Project: PA23-026- Cornelius Lacey PRD – Technical Review 2
Applicant: KM Capital, LLC
Property Addresses: 8310 Sunnyside School Rd and 4427 83rd Ave NE, Marysville, WA 98270
Project Description: 67 Lots – PRD

Regarding: Applicants response to Technical Review Letter for Preliminary Plat,

Figure 1. Tall retaining walls must be terraced with landscaping as depicted below.

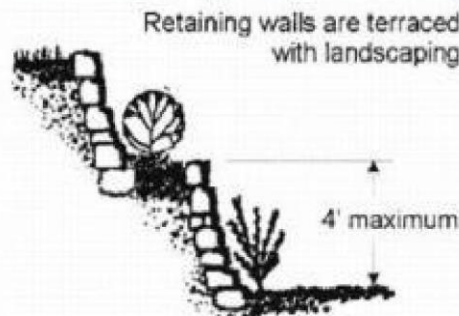
1. Pursuant to [MMC 22D.050.030\(4\)\(e\)](#), if retaining walls taller than four feet are used, and are visible from the street or adjacent property, they shall be terraced so that no individual segment is taller than four feet. Any walls ultimately permitted exceeding 4 feet shall comply with these requirements. Walls on lots 4, 38-43, 18, 10, 57, and 5, as well as some others, have walls exceeding 4 feet. ***These will need to be terraced per the standard below and*** depicted on the plans. The landscape plan does not depict plantings that will screen many of these proposed walls.

Applicant Response: Blank wall landscaping has been provided on Lots 4, 39, a portion of 43, 47, 21 and 20. Walls on other lots are either less than 4 feet or they are not visible from the street or adjacent

property. In many cases the road is higher than the adjacent property and therefore any retaining wall does not need to be screened.

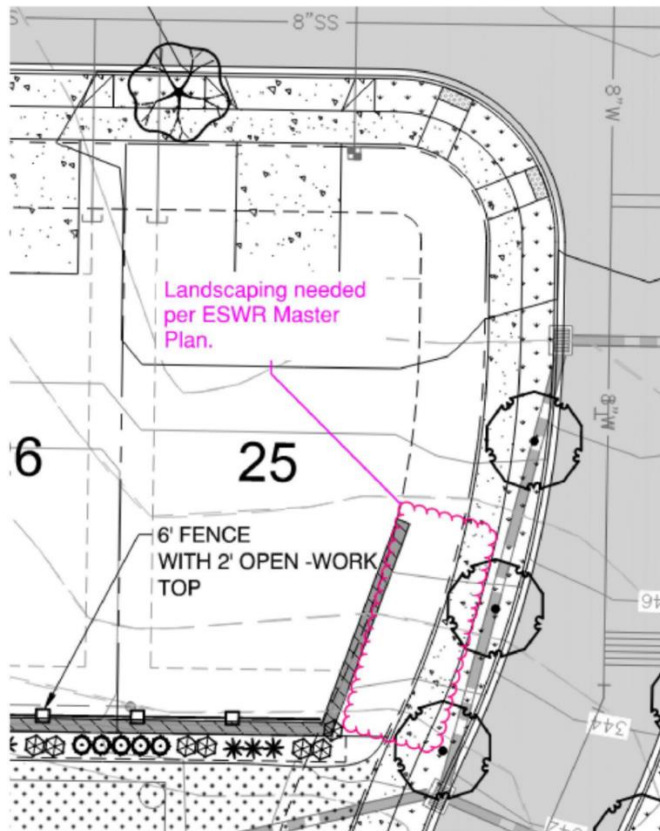
2. Prior to civil construction plan approval, please provide a detail of the 5-foot asphalt walking path.

Applicant Response: Asphalt path detail provided on the Civil plan.
